SUNDRY NOTICES AND REPORTS ON WELLS

7. If Unit or CA/Agreement, Name and/or No.
East Eumont Unit8. Well Name and No.
128

30-025-06065

OXY USA WTP LP
East Eumont Unit #128
API No. 30-025-06065

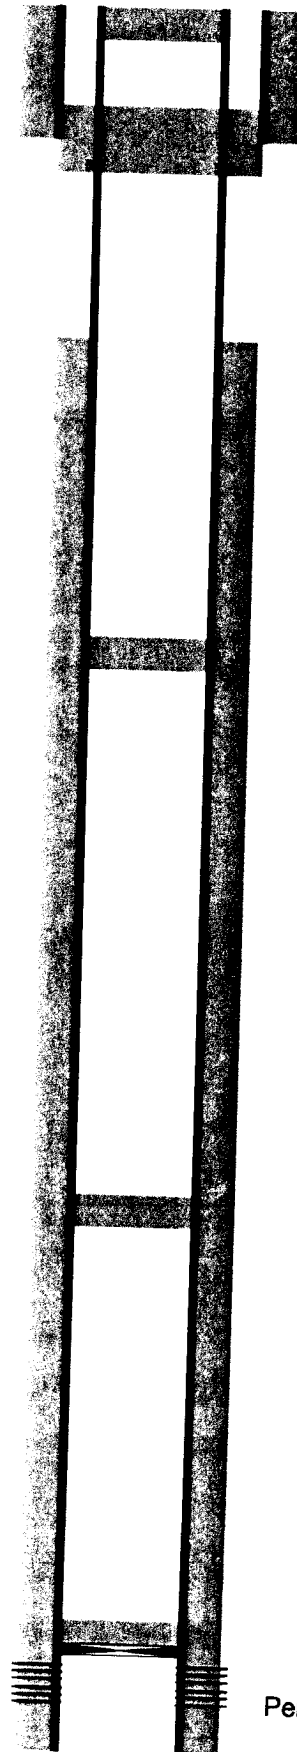
1. Approval is granted to plug this well with the following modifications to the proposed procedure:
2. The 5.5 inch to 8.625 inch casing annulus must be cemented to the surface.
3. All plugs below the surface plug should be tagged for casing shoes and the top and base of the salt.

*****All plugs below the surface plug must be at least 100' and 25 sacks of cement.**
